# Access Compliance Report

## Public Rights-of-Way

### (Curb Ramps)

Intersection ID: 42486	Main Street: ALEXANDER_MARTIN_AV	Cross Street: ALMA_BLOUNT_BV	Location: NE
ADA ID: 2BD14247C8A6	Ramp Type: Perp	Initial Pass/Fail: Fail	Overall Compliance: No
Severity Score: 21.25			
Codes/Mitigation Info/Possible Solution		Field Measurements/Component Compliance

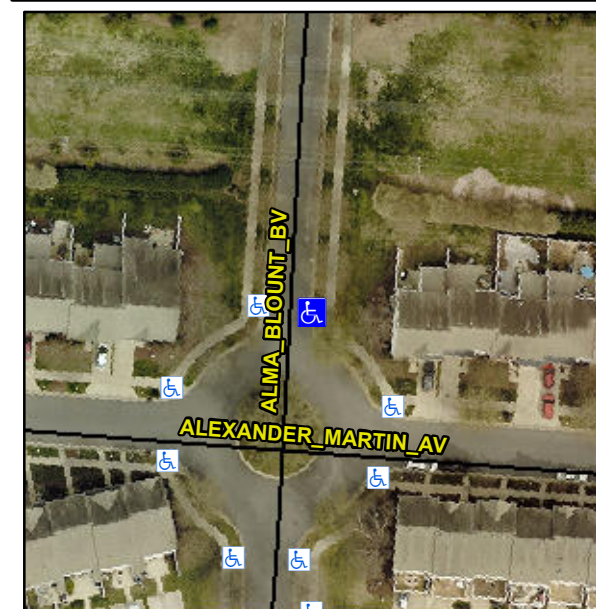
**R304.5.1, R304.2.2**

Compliance	Description	Data	Compliance	Description	Data
N/A	Ramp Length (in)	75.5	No	Ramp Slope (%)	11.8
No	Ramp Width (in)	42.0	Yes	Ramp XSlope (%)	0.4
N/A	Flare Type LT	N/A	N/A	Flare Type RT	N/A
N/A	Flare Slope LT (%)	N/A	N/A	Flare Slope RT (%)	N/A
N/A	Flare Traversable LT?	N/A	N/A	Flare Traversable RT?	N/A
N/A	Landing Length (in)	N/A	N/A	DWS Provided?	N/A
N/A	Landing Width (in)	N/A	N/A	DWS Contrast?	N/A
N/A	Landing Slope (%)	N/A	N/A	DWS Length (in)	N/A
N/A	Landing X Slope (%)	N/A	N/A	DWS Full Width?	N/A
N/A	Landing Curb? (Y/N)	N/A	N/A	DWS Offset (in)	N/A
N/A	Shared Landing?	N/A			
N/A	Gutter Ponding?	N/A	N/A	Gutter Slope (%)	N/A
N/A	Gutter Lip Ht (in)	N/A	N/A	Gutter X Slope (%)	N/A
N/A	Painted X Walk1?	No	N/A	Painted X Walk2?	N/A
	X Walk 1 Direction	To NW		X Walk 2 Direction	N/A
N/A	X Walk 1 Width (in)	N/A	N/A	X Walk 2 Width (in)	N/A
	X Walk 1 Slope (%)	1.8		X Walk 2 Slope (%)	N/A
	X Walk 1 X Slope (%)	0.3		X Walk 2 X Slope (%)	N/A

**Remove & Replace Entire Ramp.**

Total Cost: \$ 1850.00
